MEMO

To: Kristopher Byrd, Well Construction Manager
From: Tommy Laird, Well Construction Program Coordinator
Subject: Review of Water Right Application LL-1962
Date: May 15, 2024

Groundwater Application Review Summary Form

Application # LL- 1962

D. WELL CONSTRUCTION, OAR 690-200

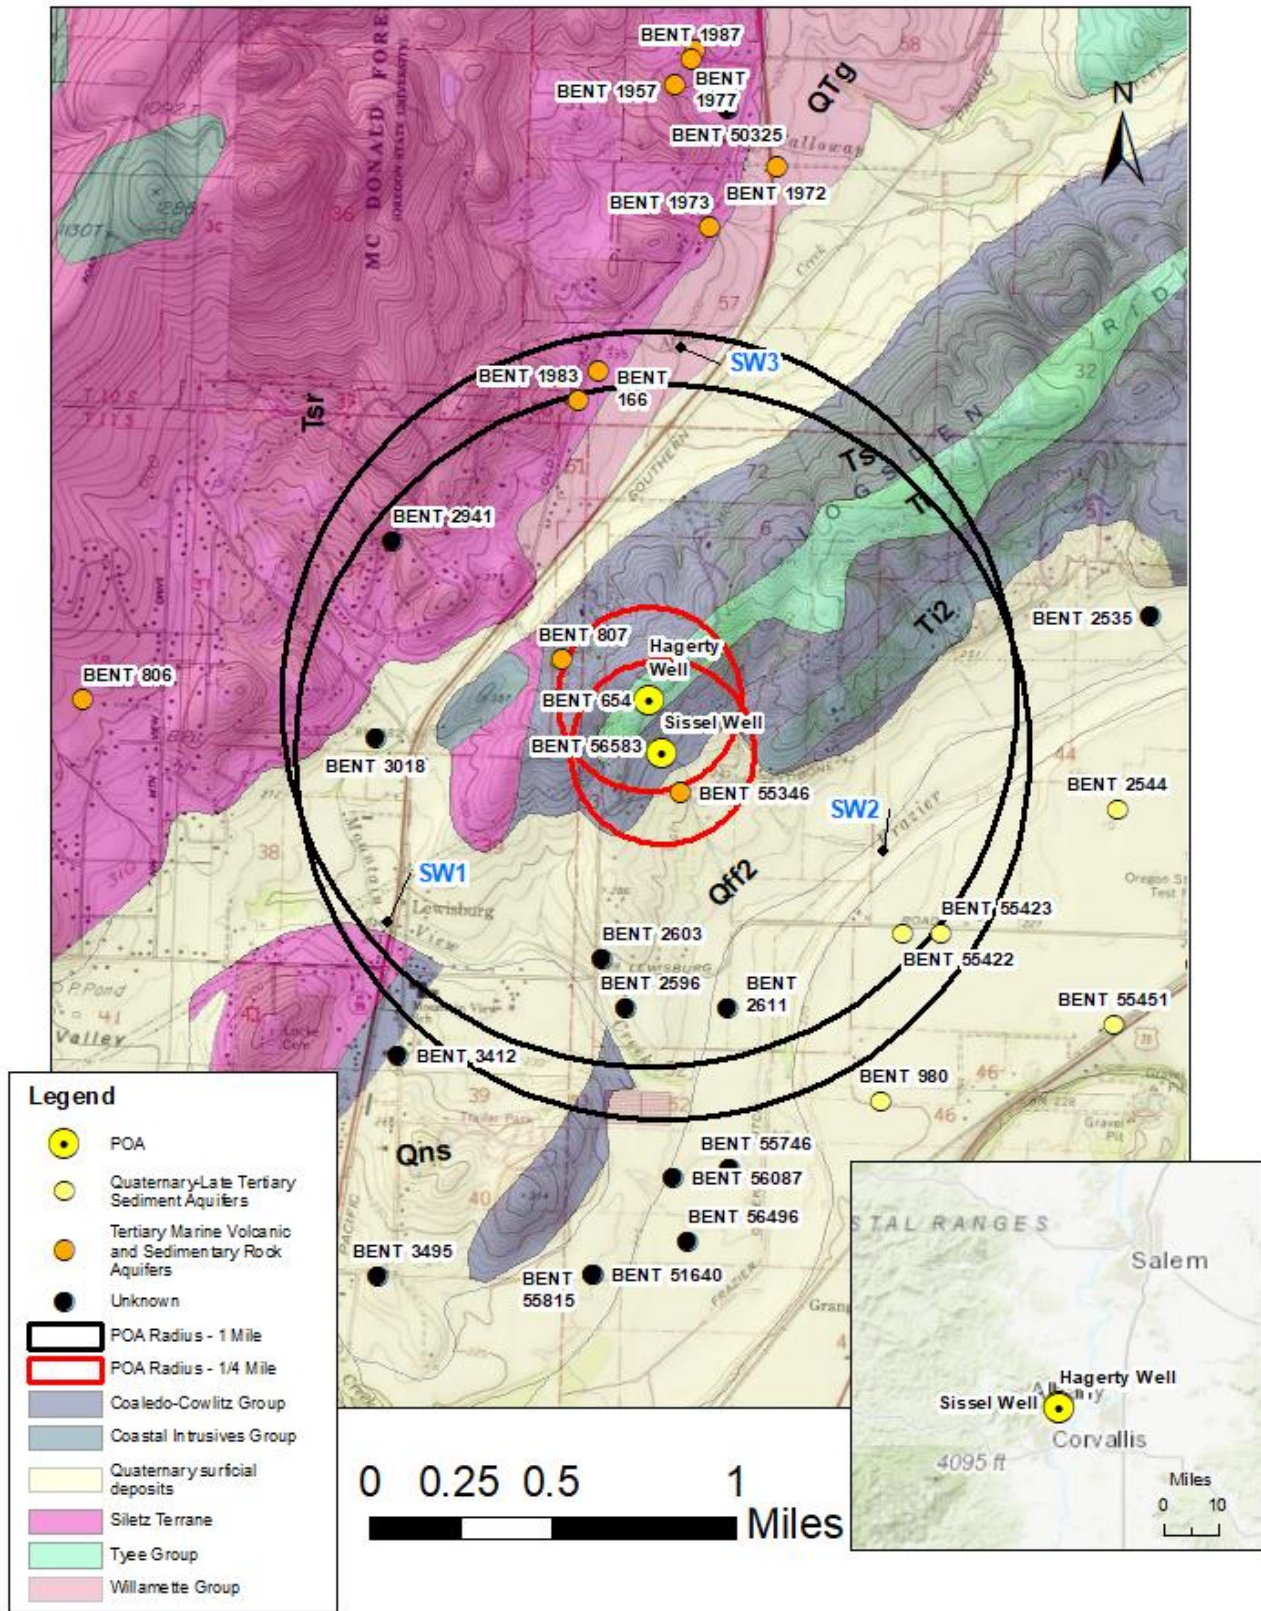
D2. **THE WELL does not appear to meet current well construction standards based upon:**

D3. **THE WELL construction deficiency or other comment is described as follows:** _____

D4. **Route to the Well Construction and Compliance Section for a review of existing well construction.**
